SERVICE BULLETIN NO. 19

Section VIII, Division A
Service Bulletin
Issued January, 1964

RE - DESIGNED AIR VANE GOVERNOR

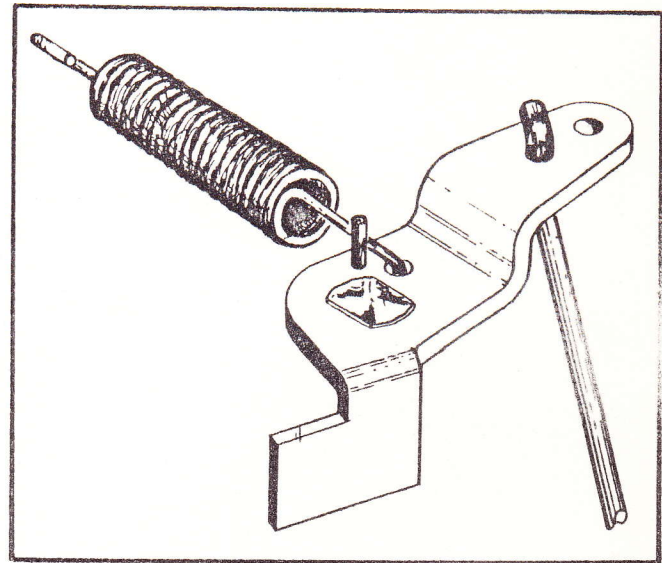
A replacement Air Vane Governor Part 107-34 is available to eliminate surging. This new air vane can be used on all engines now using the 107-30 air vane. On some models when installing the new air vane, it will be necessary to change link, spring and throttle shaft. Listed below are the engines and required parts.

For Series 401, 407-0002, 411, 415 Engines:

1. Use 107-34 Air Vane
2. Use 159-161 Link
3. Change Link and Spring hook - up as shown
